Sedan Range

05.2-07

## TECHNICAL BULLETIN

Poor Drivability/MIL Illumination –  
Check Throttle Synchronization

ILLUSTRATION 1

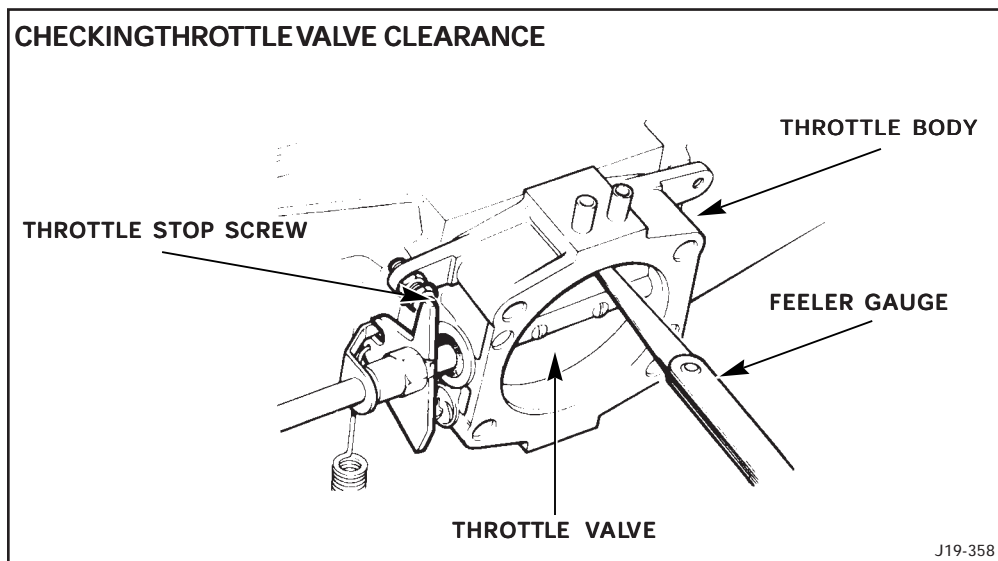
1. Check that both throttle valves are centered horizontally and vertically in the throttle bodies.
2. With the throttle valve closed, use a feeler gauge to check the clearance between the throttle valve and the throttle body (Illustration 1).

Check the clearance at the bottom as well as at the top of the throttle valve. If a significant difference is found between the top and bottom measurements, the throttle valve may be offset on its shaft. If both measurements are within the above range, do NOT adjust the throttle stop screw (Illustration 1).

Throttle valve checking clearance: 0.001 - 0.003 inch (0.025 - 0.076 mm)

3. If adjustment is necessary, set the throttle stop screw to achieve the following throttle valve clearance range:

Throttle valve setting clearance: 0.001 - 0.0015 inch (0.025 - 0.04 mm).

ILLUSTRATION 2

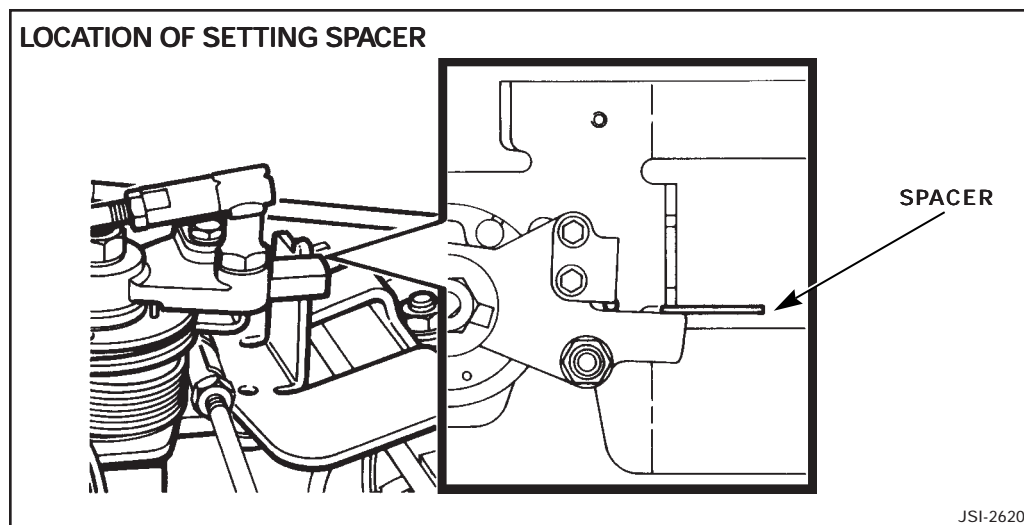
1. Loosen both locknuts on the two linkage rods between the center throttle turntable and the throttle levers.
2. Disconnect one linkage rod from its ball pin on the linkage rod bracket.
3. Position a 0.079 inch (2.00 mm) spacer between the linkage rod bracket and its stop (Illustration 2).

4. Turn the linkage rod that is still connected to increase its length until the throttle lever clears its stop screw.
5. Shorten the linkage rod until the throttle lever just touches its stop screw. Tighten both lock nuts on the linkage rod.

6. Connect the second linkage rod and repeats steps 4 and 5 to adjust its length.
7. Remove the spacer inserted between the linkage rod bracket and its stop.

8. Check the backlash by turning the linkage rod bracket of the throttle turntable slightly clockwise. A gap should appear between the bracket and its stop before either throttle lever leaves its stop screw.  
Gap dimension: 0.062 - 0.094 inch (1.57 - 2.39 mm)
